BOUNTY – PACK 10

Amendments to pieces 19A, 19B and 20 from tablet 10-04

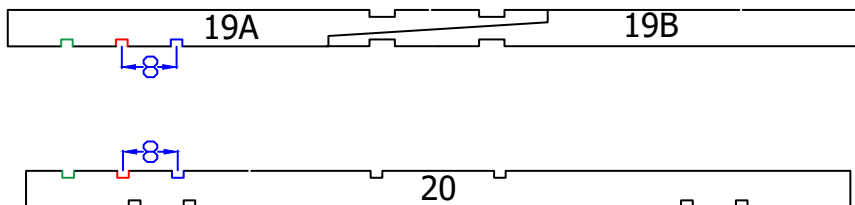
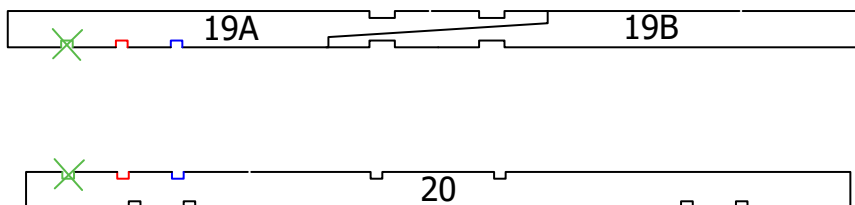
Detach pieces 19A, 19B and 20 from table 10-04.

Join pieces 19A and 19B together. Pay attention to the notches highlighted in green and red in the drawing.

Position the pieces as shown. Starting from the centre of the notches highlighted in red in the drawing, measure 8mm to the right and carve new notches using a file.

The notches highlighted in green in the drawing should be ignored in the following assembly sessions. Use only those highlighted in red and blue in the drawing.
